## Annexure 2 – SEPP (Housing for Seniors or People with a Disability) 2004

The following table provides an assessment of the relevant clauses of SEPP (Housing for Seniors or People with a Disability) 2004:

Figure 1: Landscaped Area Calculation

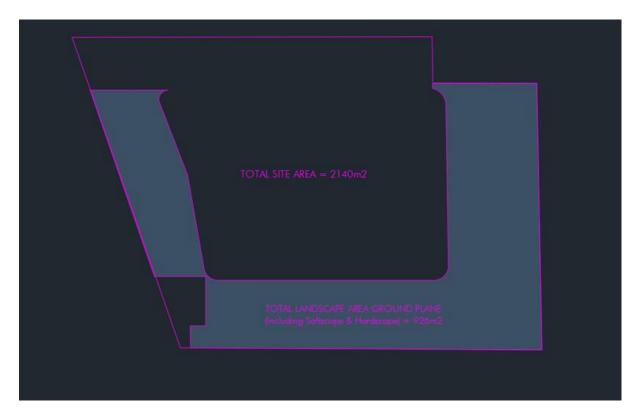
(c) landscaped area: if:  (i) in the case of a development application made by a social housing provider – a minimum of 35 square metres of landscaped area per dwelling is provided; or  (ii) in any other case – a minimum of 30% of the area of the site is to be landscaped	The SEPP defines landscaped area as follows:  Iandscaped area means that part of the site area that is not occupied by any building and includes so much of that part as is used or to be used for rainwater tanks, swimming pools or open-air recreation facilities, but does not include so much of that part as is used or to be used for driveways or parking areas.	Yes
	Excluding the parking and building areas, the proposed landscaped area is 43%. The applicant submitted a diagram supplementing the architectural plan package (shown below in Figure 1) to detail this calculation.
